Re: Parking Lot Specialties–South Building
Site Plan Review No. 2
City of Carlisle, Iowa (City)

Strand Associates, Inc.® (Strand) has completed the second review for the Parking Lot Specialties–Addition Site Plan Amendment dated March 25, 2024, and has the following comments and questions:

Parking Lot Specialties – SITE PLAN – 210106-1

Response to City Review Comments for Site Plan received 4/08/2024

PARKING LOT SPECIALTIES - SOUTH BUILDING
CARLISLE, IOWA
GRADING & UTILITY PLAN

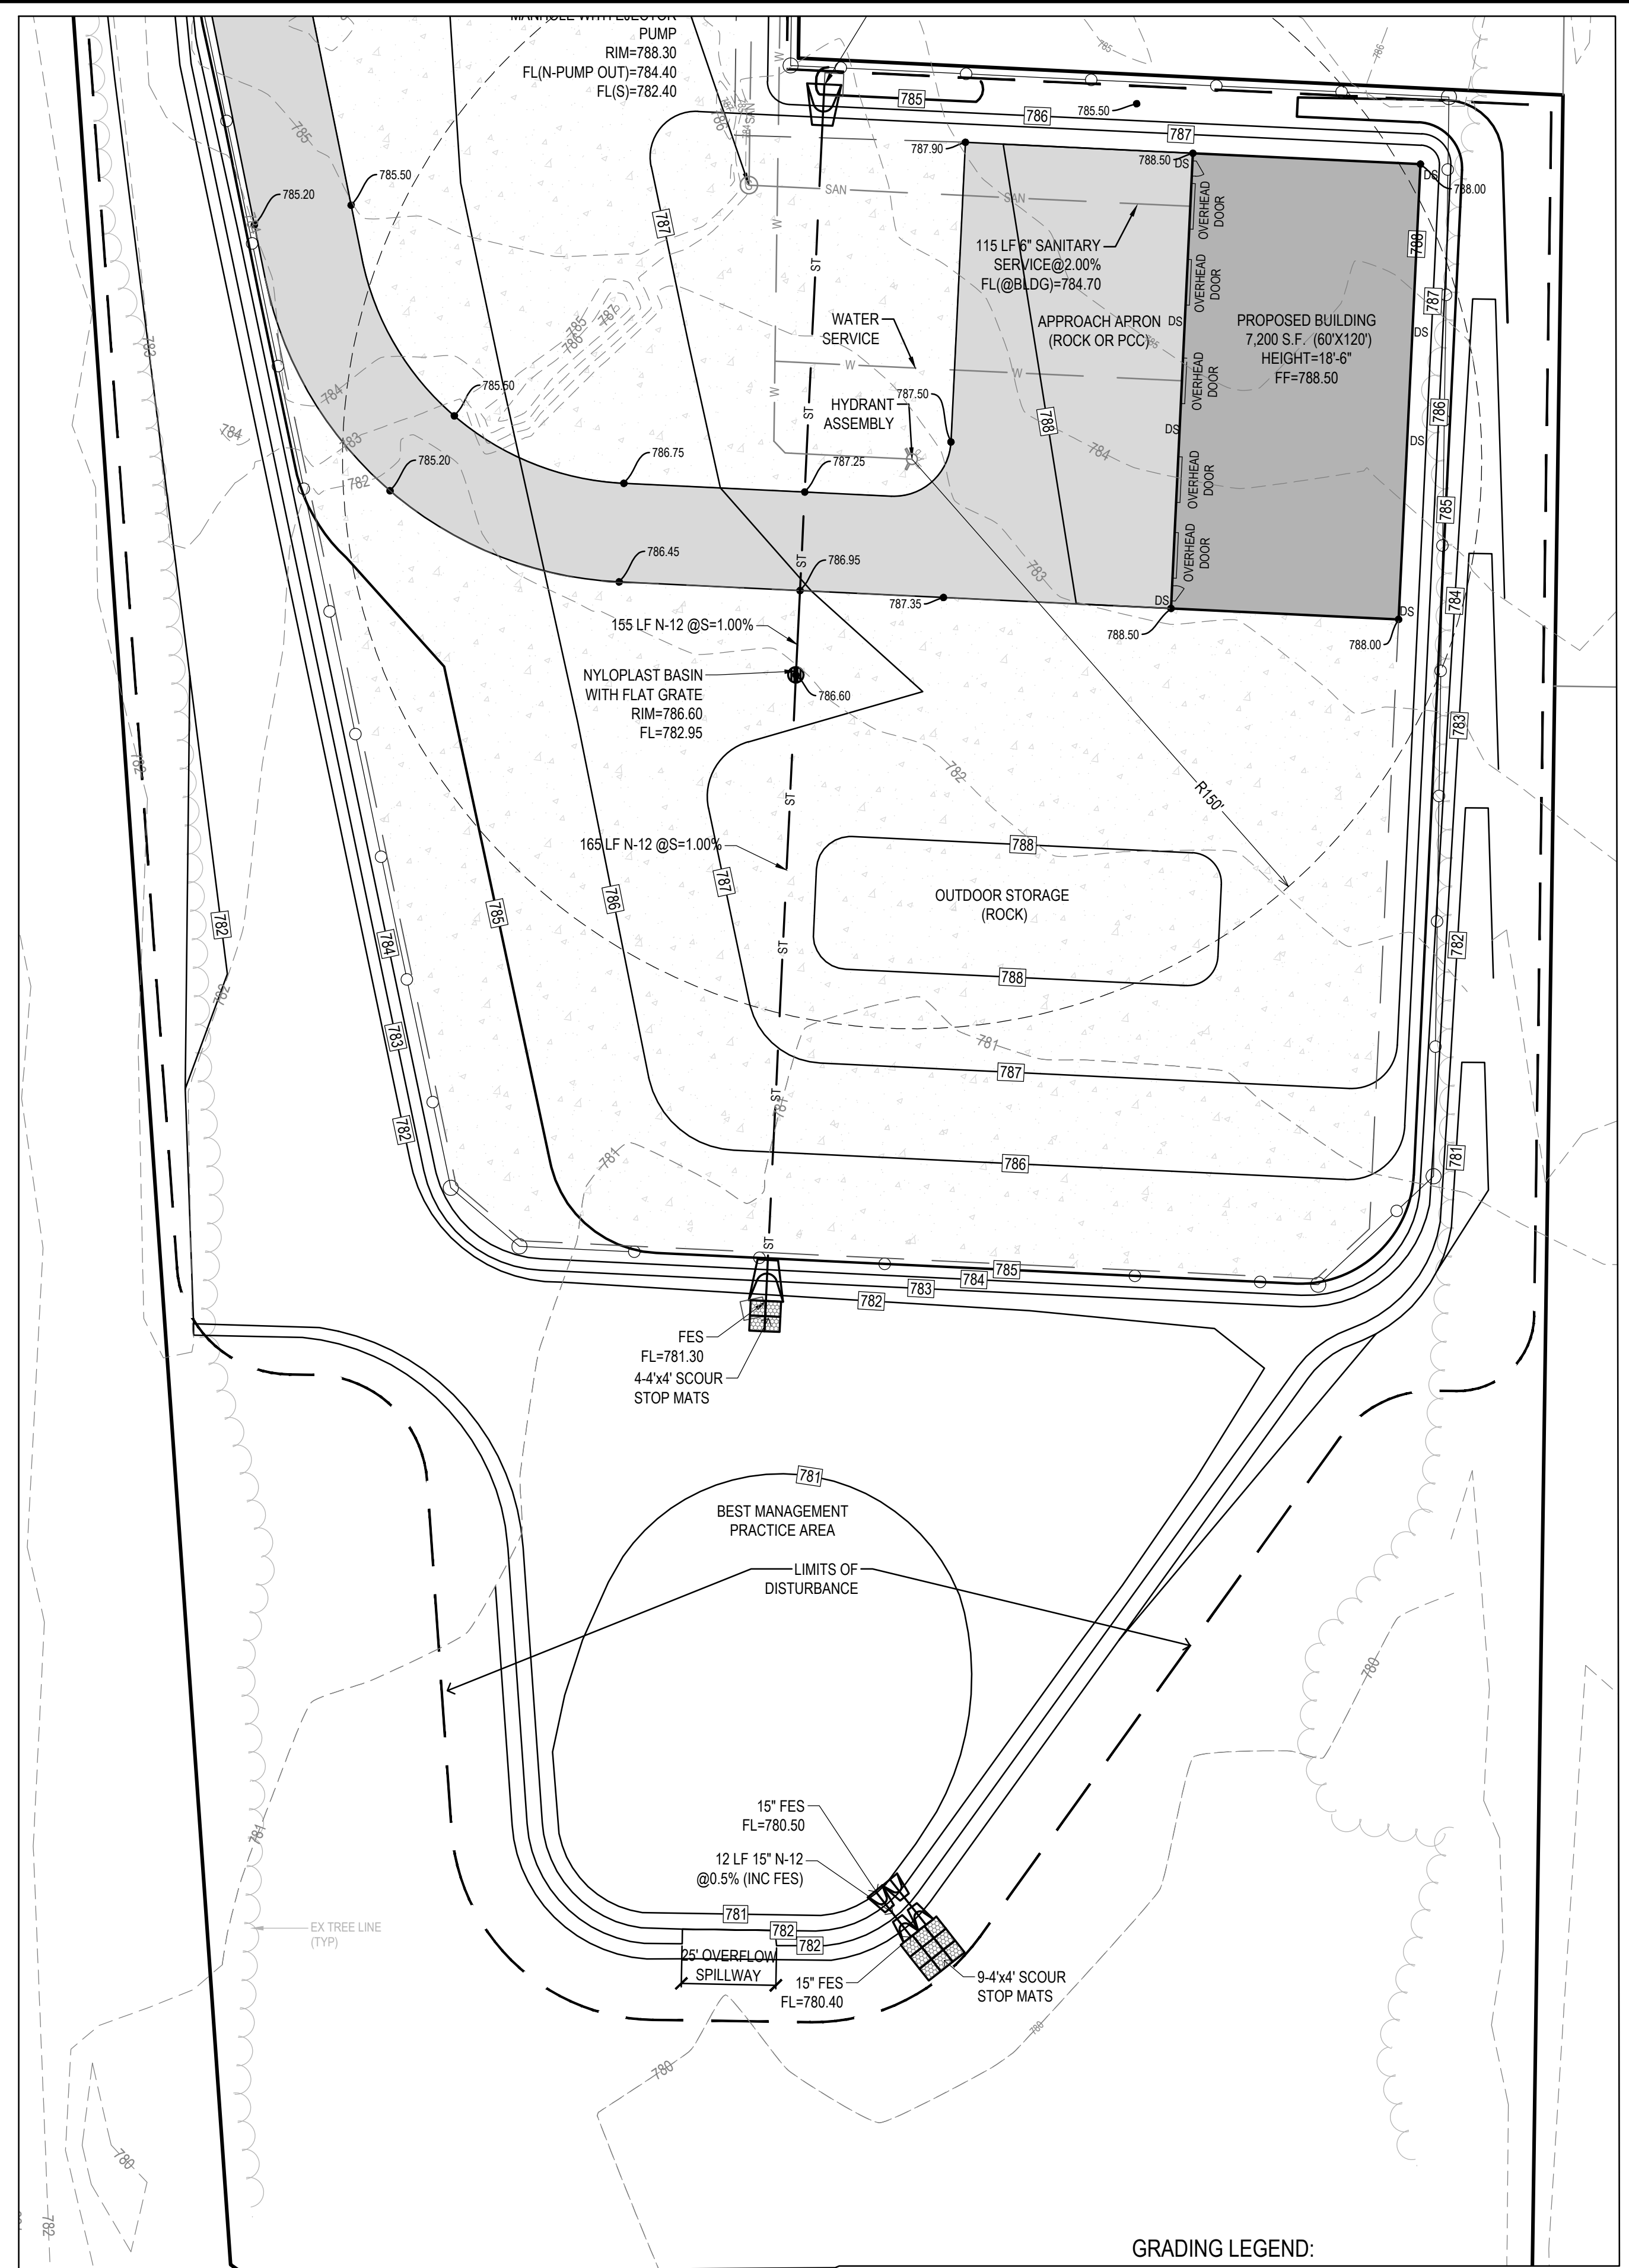
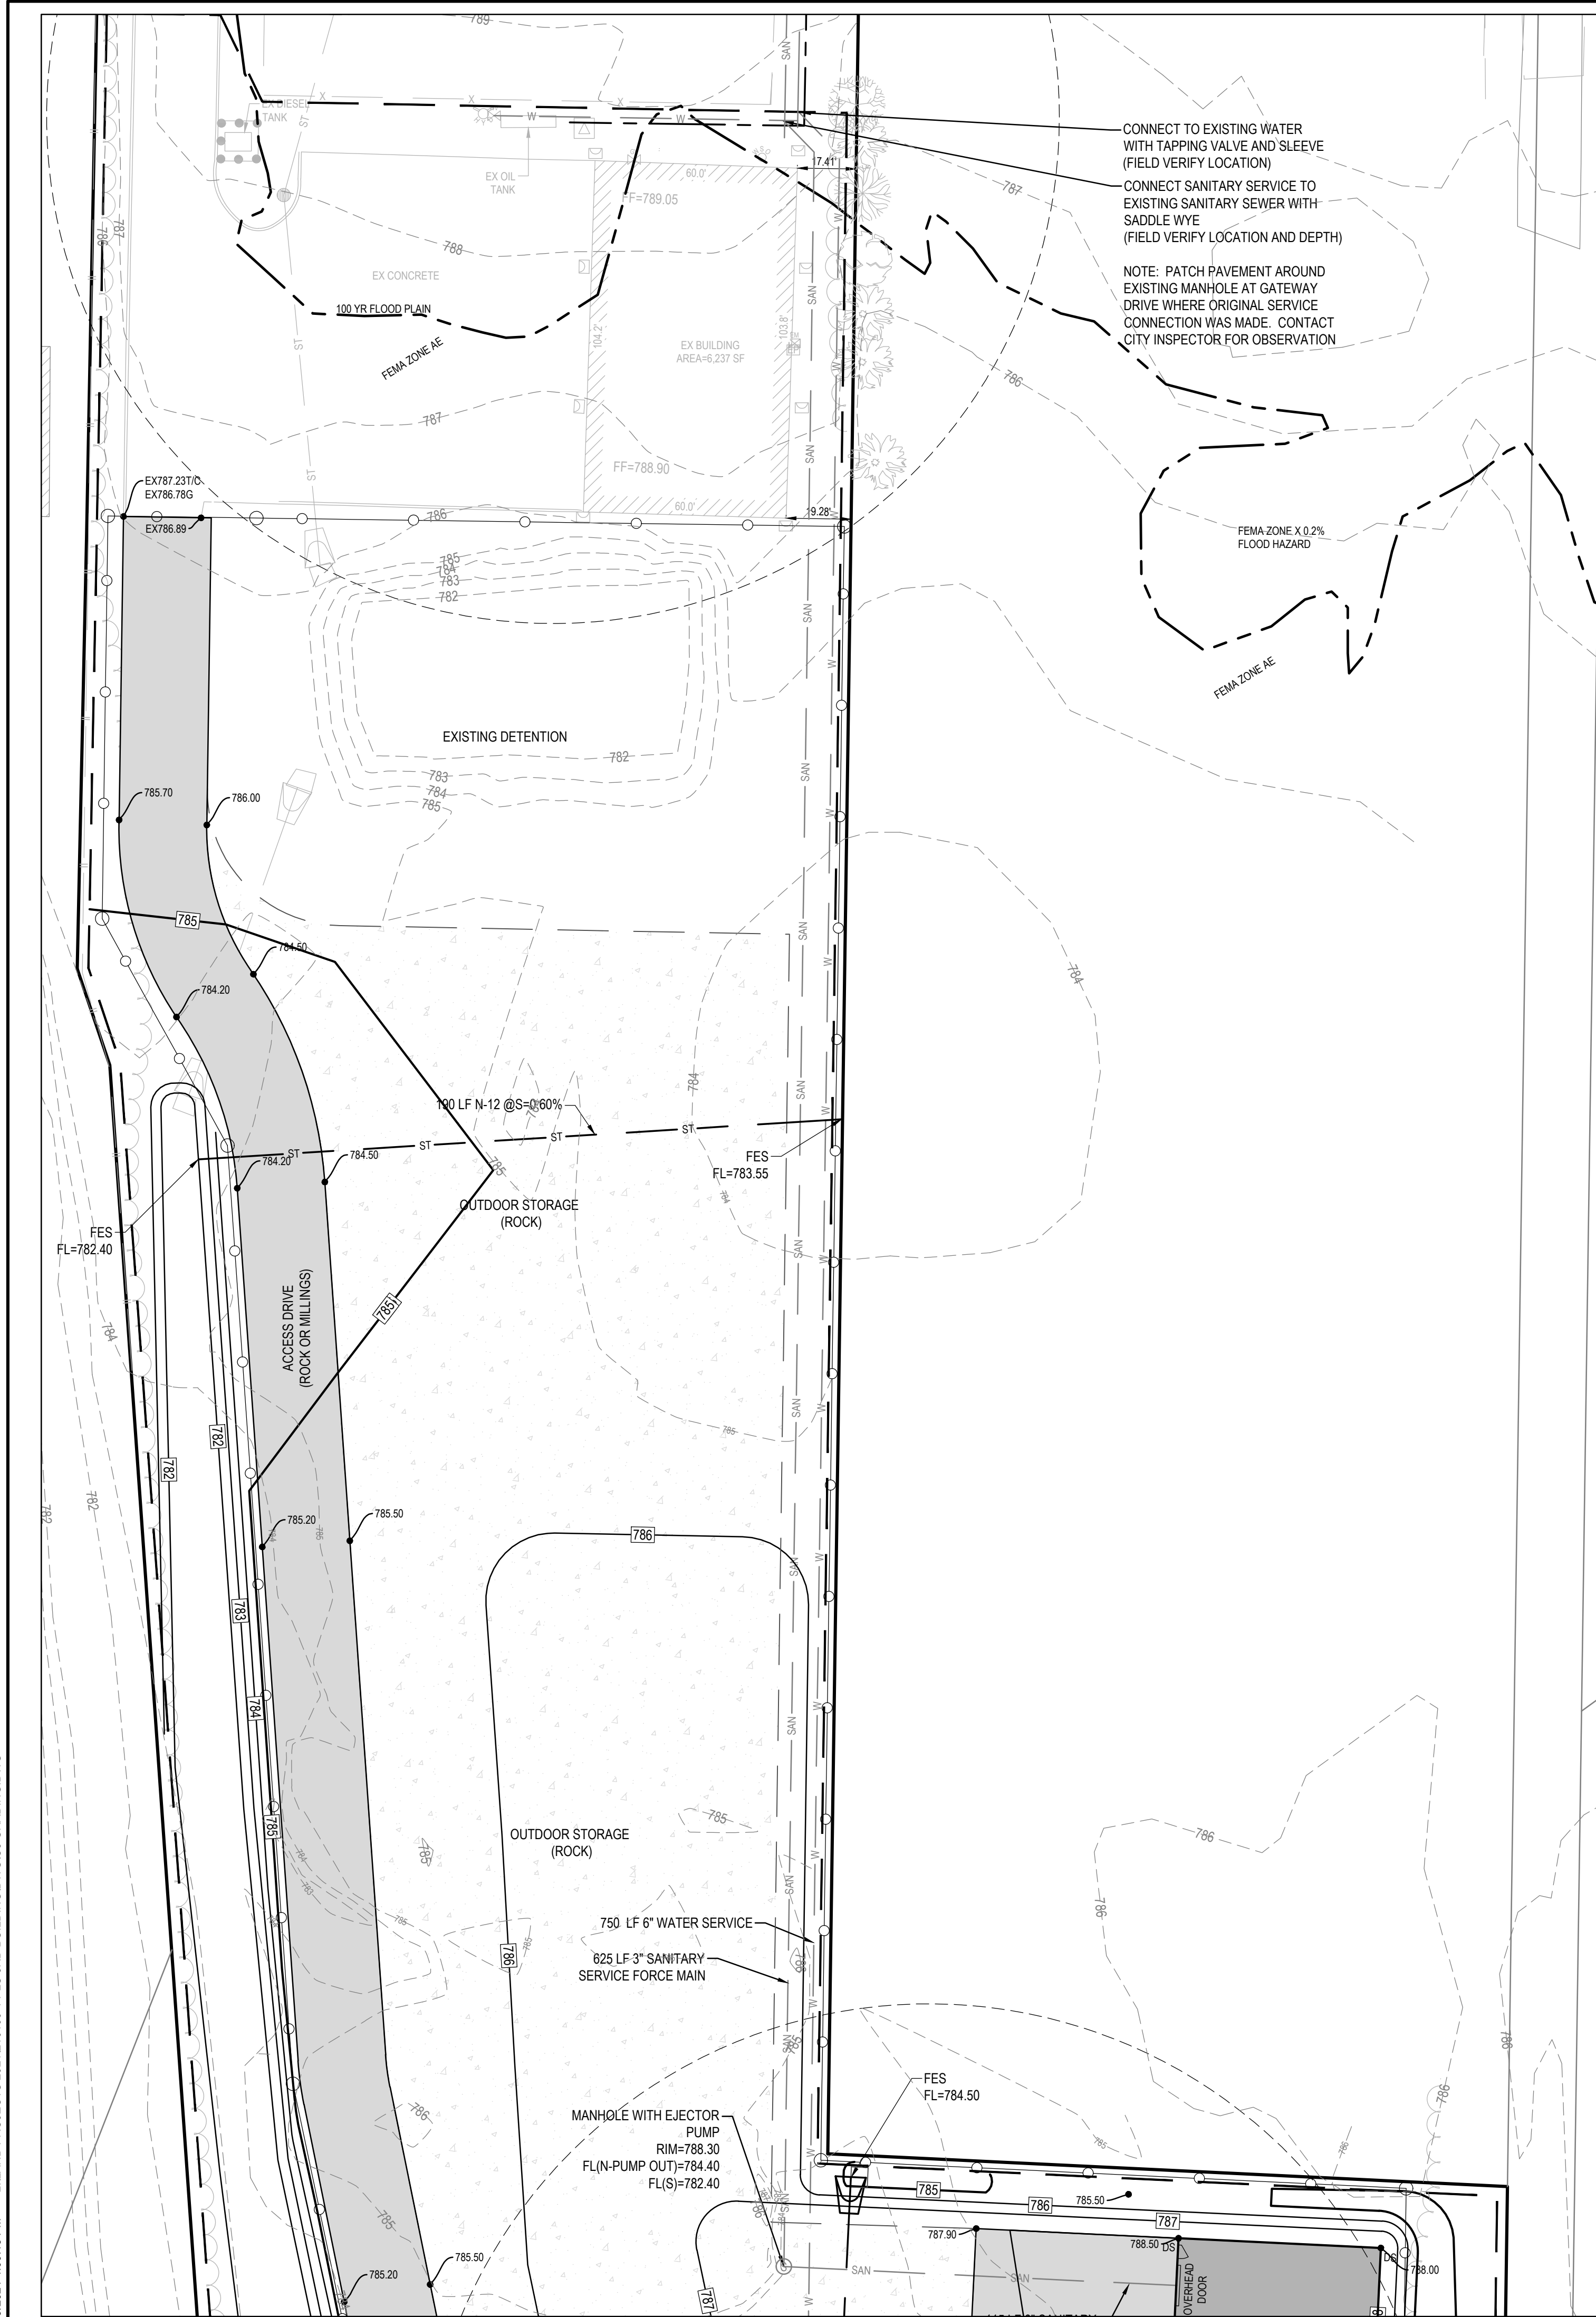
Sheet C3.2–Grading and Utility Plan

1. Roof drains shall discharge to a pipe, hard surface, or splash block. Please clarify how erosion is mitigated at the downspouts shown.
2. Will there be any servicing of vehicles in this building or other need for a sand/oil separator? Please clarify.

Sheet C3.2 – Grading & Utility Plan

1. Splash blocks have been called out for the roof drain discharge
2. There is no vehicle servicing planned in this building that would require a sand/oil separator
